Usage of GATE Message and 3 reasons to separate it into two messages

Glen Kramer, Teknovus

Reason 2: Message Semantic is Different

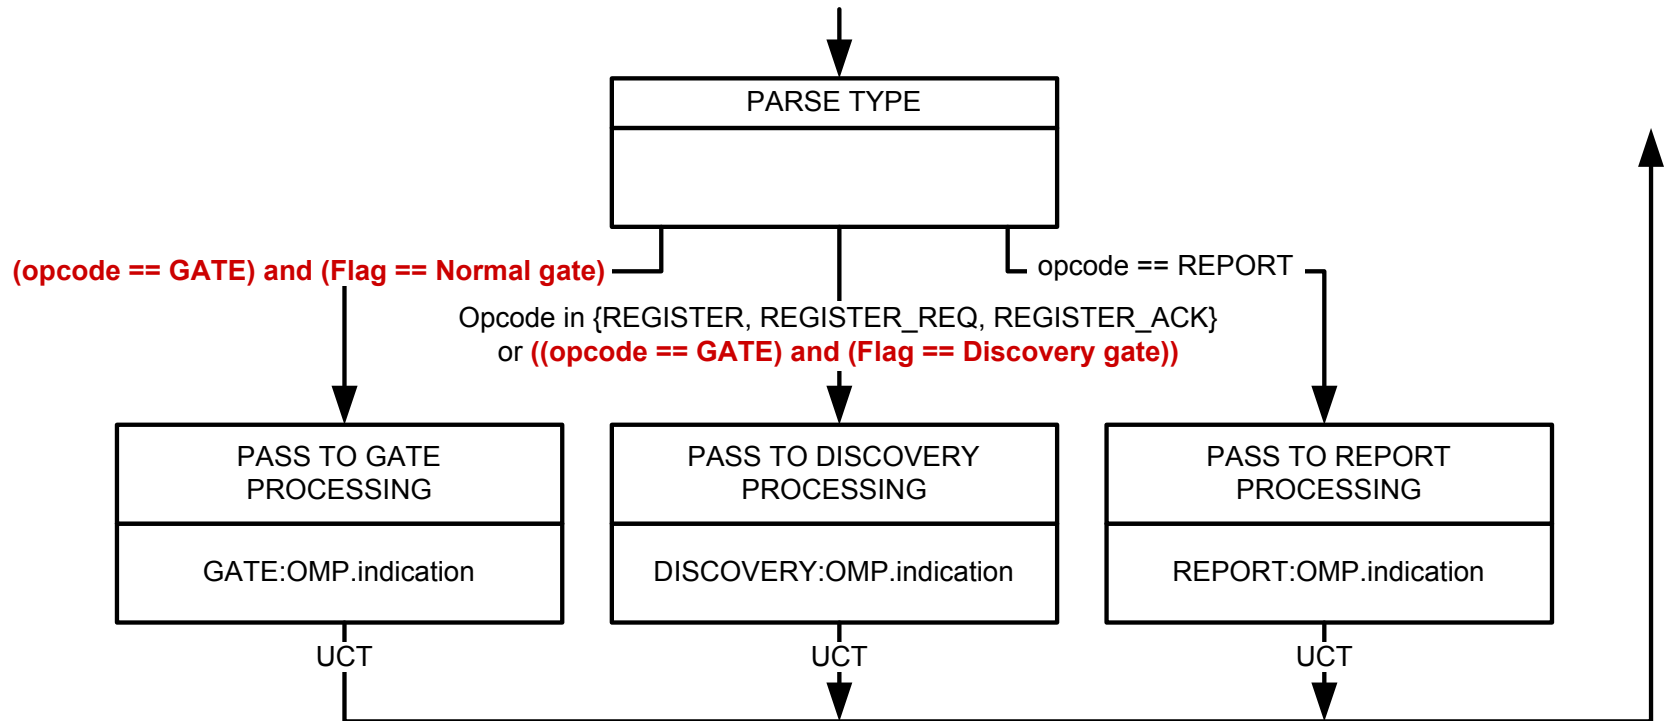
- Start Time – laser turns on at Start Time
- Length – interval of time during which the laser remains on and data (or IDLES) being transmitted

- Start Time – laser turns on only after an additional random delay added to Start Time.
- Length – used to derive the maximum bound on random delay
- Laser remains on for short and constant interval independent on Length

Reason 3: No Opcode-Independence

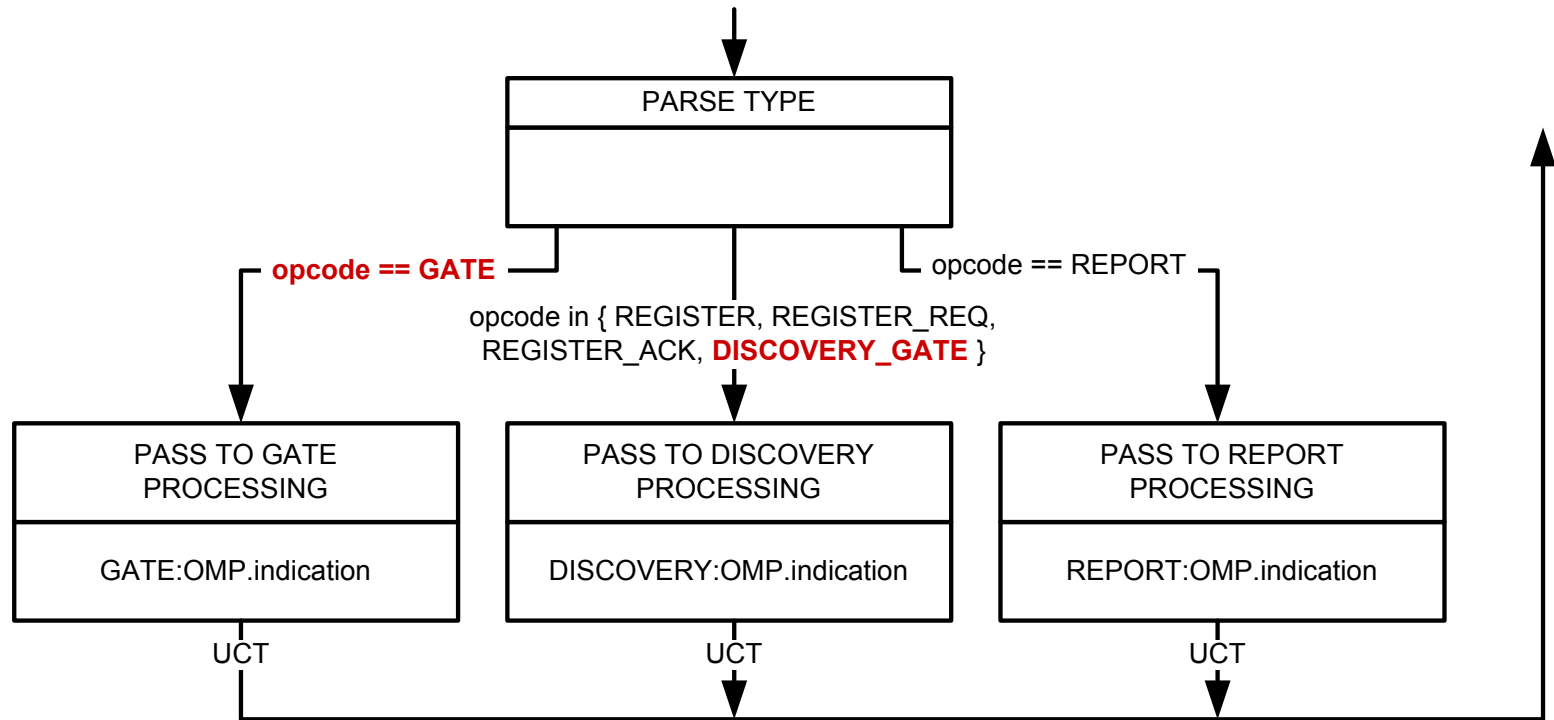
MAC Control messages with the same opcode are passed to different functional blocks for processing (based on a parameter value)

- Additional MPCP opcode (**DISCOVERY_GATE**) should be defined (currently 5 opcodes defined)
- Message should only contain relevant parameters
- Minimum changes
